# Technical Bulletin

**60 17 03** June 7, 2017 **2043031** Supersedes Technical Bulletin 60-16-03 (V601603) dated February 25, 2016 to include additional model year.

### Rattle or Creaking Noise from Panoramic Sunroof

Figure 1) Area to apply the self-adhesive film (glass panel removed for illustration purposes).

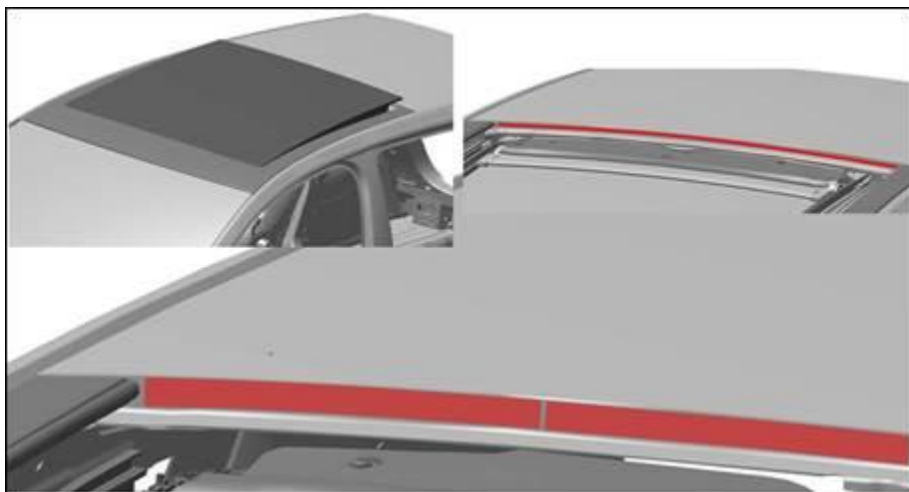
A rattle or creaking noise may be heard from the rear of the Panoramic Sunroof when driving on uneven roads with the sunroof closed.

Rattle or creaking noise is caused by the relative movement between the glass panel seal and body when the sunroof is closed

- Cut the protective film sheet (part number AKL 448 300 04) into 3 strips 12 mm wide x 290 mm (290 mm is the length of the long side of the protective film sheet).
- Move the glass panel to the tilt open position.
- Thoroughly clean the contact area between the rear glass panel seal and the body.
- Apply the self-adhesive protective film strip to the body (Figure 1, in red).
- Close the glass panel.
